BAR Meeting
March 19, 2014

ISSUE: Permit to Demolish – Shed
Certificate of Appropriateness – Fence Construction

LOCATION: 615 S Pitt Street

BAR2014-00046 & BAR2014-00047

Detail of Board Fence

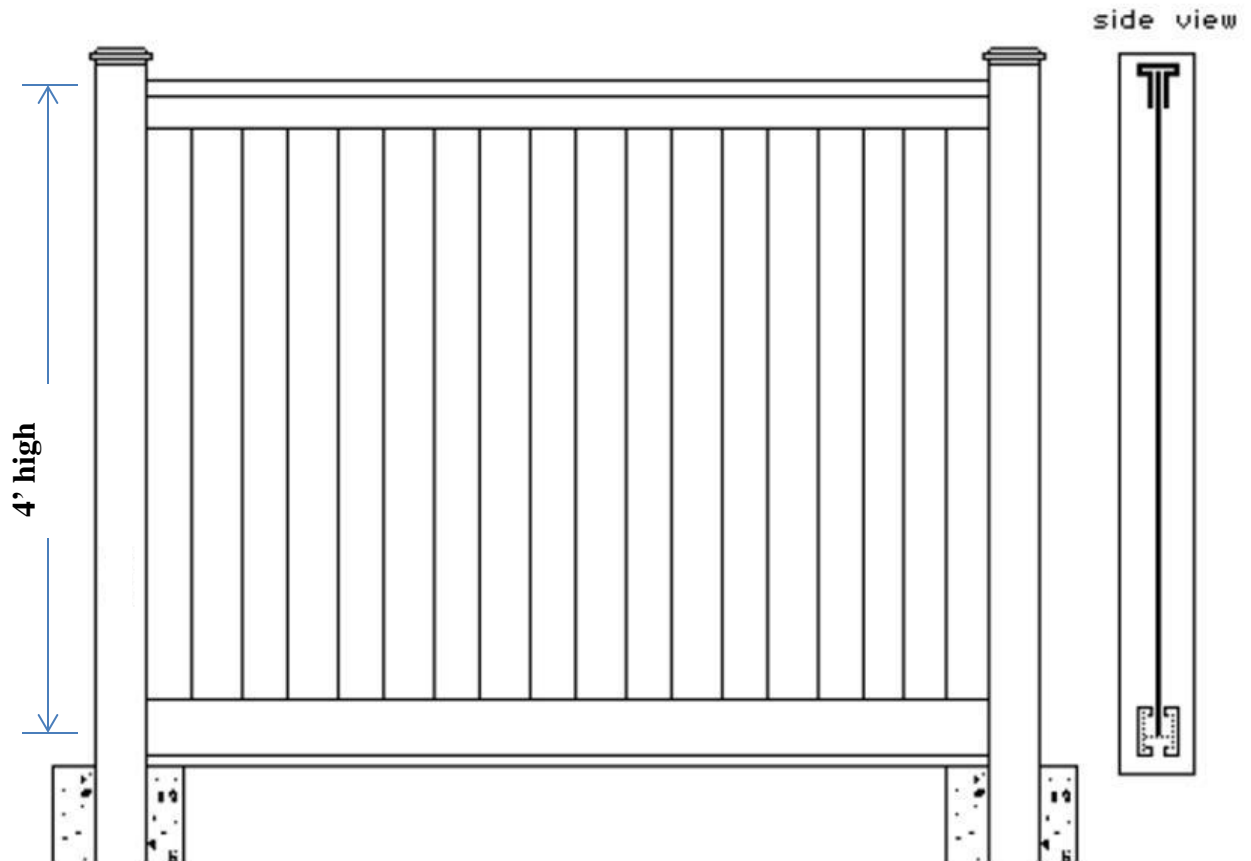
The applicant is proposing to enclose his rear yard by installing a four foot (4') high wood board fence approximately 15.5' from the rear property line. Staff finds that the fence design and location is consistent with the *Design Guidelines*. It should be noted that typically this fence would be reviewed and approved through the BAR's staff level administrative review process, but since the applicant was required to obtain a public hearing approval for the shed demolition, staff advised the applicant to add this associated fence project to the application – to avoid the separate application and permitting process.

Staff recommends approval of the application with the recommended archaeological conditions.
